**Development Review Committee  
Staff Report  
June 15, 2016**

<b>Case No:</b>	16Cell1002
<b>Request:</b>	Cell Tower
<b>Project Name:</b>	Greenwood Sylvania
<b>Location:</b>	6500 Greenwood Road
<b>Owner:</b>	Fusion Properties, LLC, Mark McAdams
<b>Applicant:</b>	Crown Castle, Bryan Brawner
<b>Representative:</b>	Christopher King
<b>Size:</b>	155 feet total height 5,727 square foot compound area
<b>Existing Zoning District:</b>	C-1, Commercial
<b>Existing Form District:</b>	Neighborhood
<b>Jurisdiction:</b>	Louisville Metro
<b>Council District:</b>	12 – Rick Blackwell
<b>Case Manager:</b>	Steve Hendrix, Planning Supervisor

Example of proposed 8' high chain-link security fence with dark brown vinyl privacy slats installed

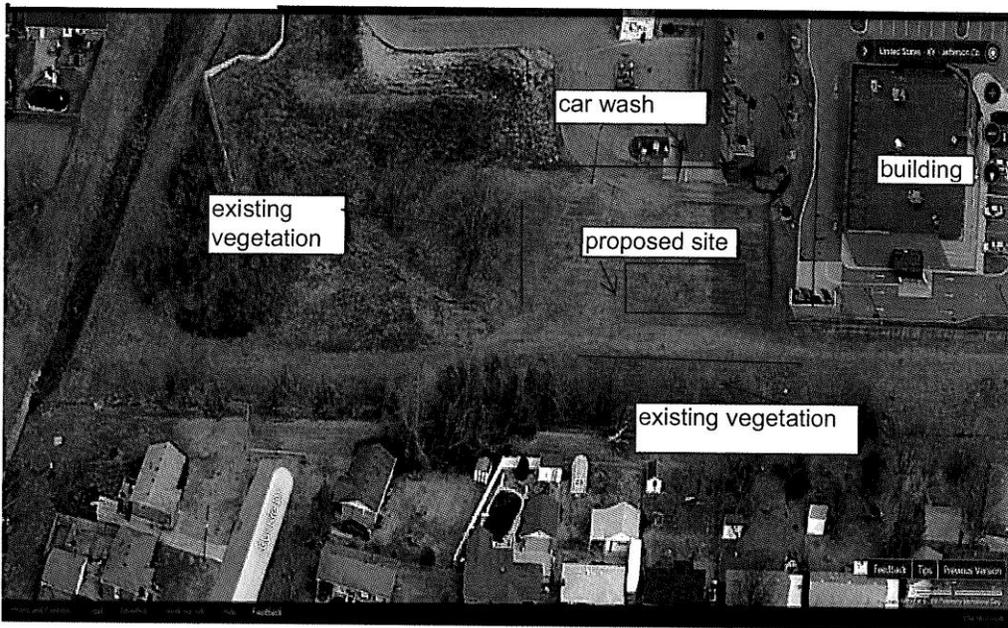
The applicant is proposing a chain link fence with “shielding barriers”, some revised elevations/site plans refer to an 8 foot high chain link fence with dark brown vinyl slats.

Section 10.4.9 states that “Chain link fencing may not, under any circumstances be used to meet any screening requirements of this regulation, nor shall slats installed as part of a chain link fence be allowed to satisfy screening requirements.”

STAFF: The waiver will not adversely affect the adjacent property owners, **if** the shielding barriers are secure and able to withstand wind and debris, otherwise, staff is not able to support.

**OVERALL SITE PLAN w/DISTANCE TO PROPERTY LINES**

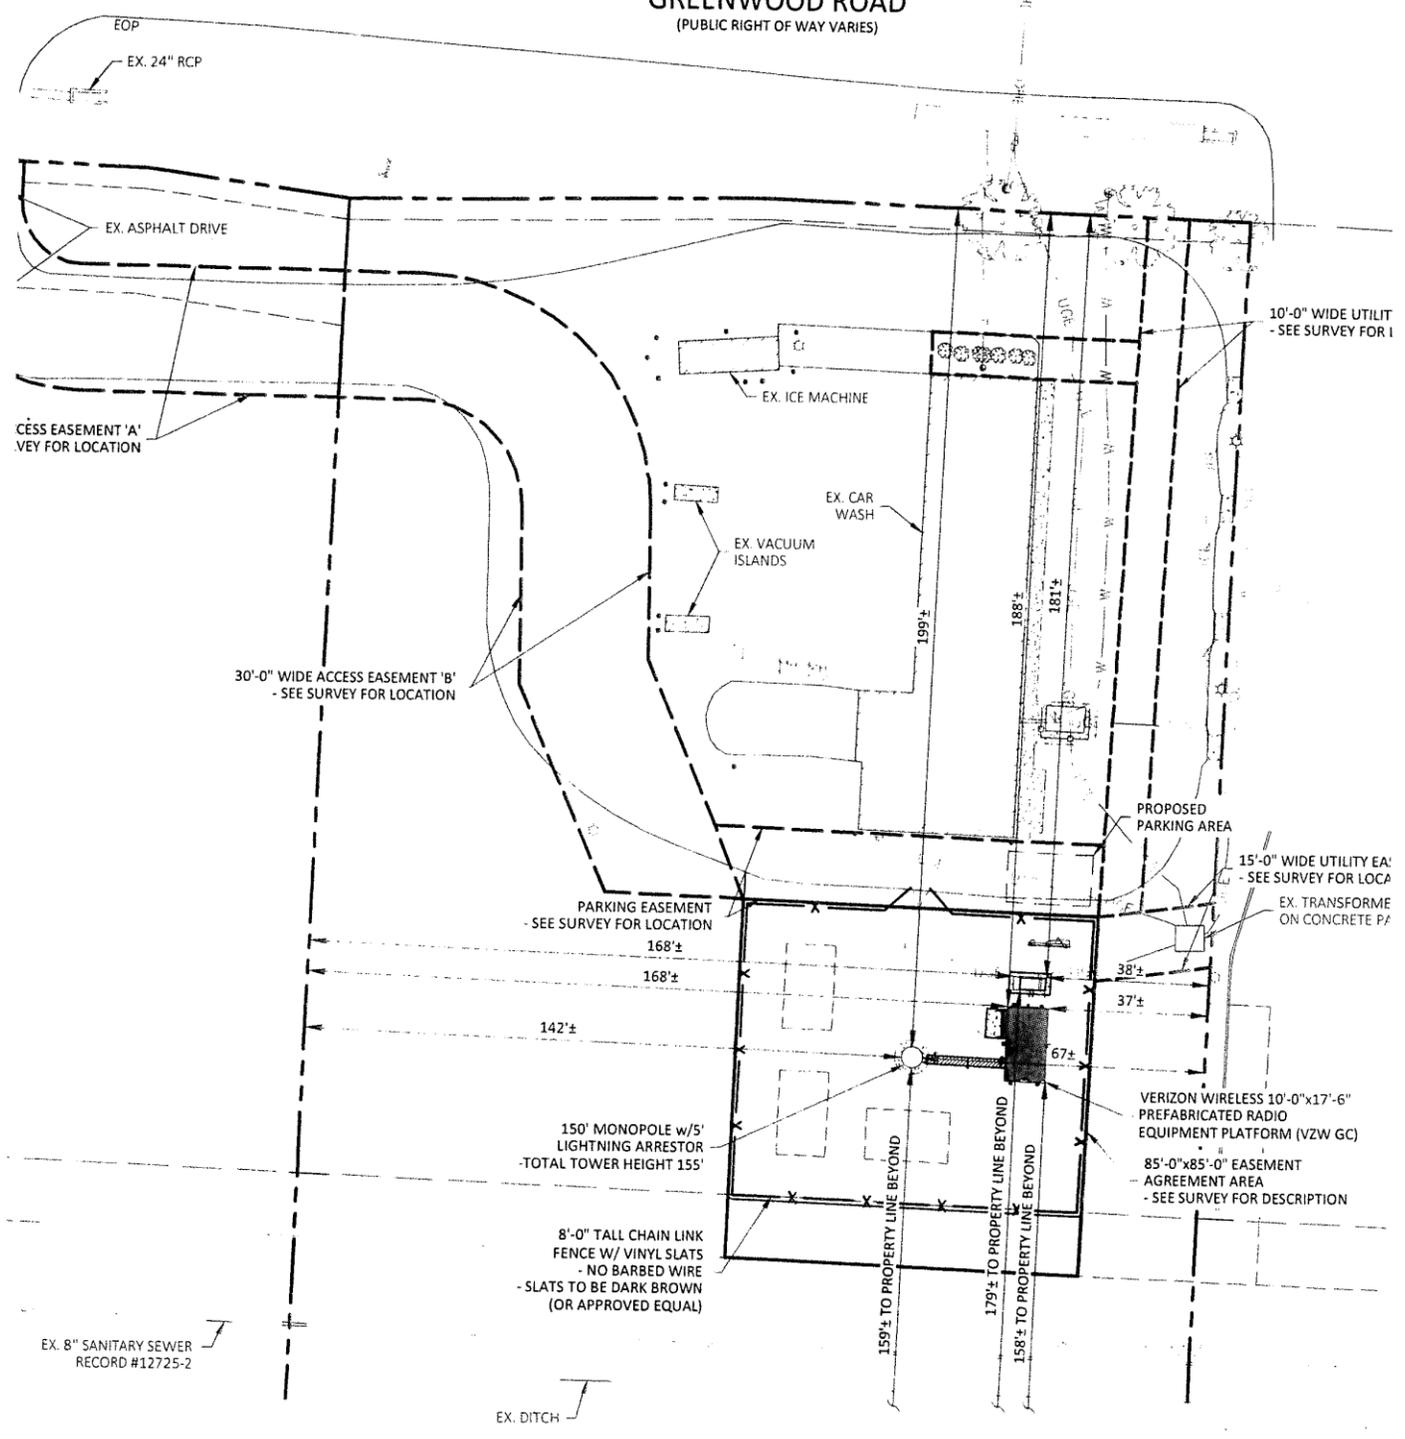
STAFF: The waiver will adversely affect the adjacent property owners to the south. Although buffered with existing trees and vegetation, the compound area needs to be buffered all year. If approved, the chain link fence with barriers will conceal the compound area, but the site still needs to be buffered.

The applicant is requesting a wireless communications facility to better serve the public and to provide co-location opportunities for other carriers. The proposed location is within a C-1 zoning district. The monopole is approximately 160 feet from the property line and roughly 230 feet to the nearest residence at 6507 Tearose Drive. The compound area is somewhat buffered by the existing car wash on the Greenwood Road to the north, existing trees and vegetation to the south, the Rite Aid Pharmacy and its dumpster enclosure on the east side and existing trees and vegetation on the west side which is located on a separate parcel. The applicant is requesting that the screen consist of an 8 foot high chain link fence with shielding barriers with no landscaping. Staff is in support of the monopole with the proposed screen, if the “shield barriers” are secure and are able to withstand wind and debris. Staff is not in support of zero landscaping, since the compound area needs to have year round buffering.
